From: [REDACTED]
To: [Gate Burton Solar Project](#)
Cc: edward.leigh.mp@parliament.uk
Subject: Upper Witham River banks breach Kexby lane.
Date: 22 October 2023 19:40:47
Attachments: [IMG_6411.PNG](#)
[IMG_6361.jpg](#)
[IMG_6363.jpg](#)
[13b76e28-f035-4784-9e59-f71987881a17.JPG](#)
[aaf7f884-d36d-4ee9-b3cc-6cbd2ff3ae8.JPG](#)
[98d954d1-82e4-45c5-81f6-40ec0ea8fb08.JPG](#)
[IMG_3908.JPG](#)
[IMG_3915.JPG](#)
[IMG_3916.JPG](#)
[IMG_3917.JPG](#)
[IMG_3930.JPG](#)

Reference GBEP IP059

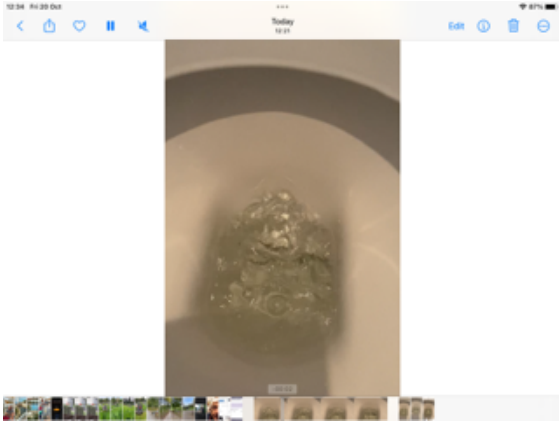
Residential properties and a business on Kexby lane were affected by surface water flooding on the 20/21st of October 2023.

The Upper Witham drainage river breached its banks in several places. Surface & ground flooding occurred to properties and surrounding fields, including the field that is bounded by the Upper Witham river on its South and Western sides. The field is the northern most site in the proposed Gate Burton Energy Park.

I enclose photographs taken over the period showing the extent of the problem.

If this field is allowed to be developed for thousands of Solar PV arrays, it is feared that the impermeable surfaces of 4m high panels will act as rainfall collectors, runoff will be concentrated onto a compacted heavy clay.

Low Carbon plan to divert surface water via swales, will in all probability exasperate an already existing problem and remove any capacity in the Upper Witham that we need to remove ponding surface water flooding from around properties before ingress occurs.
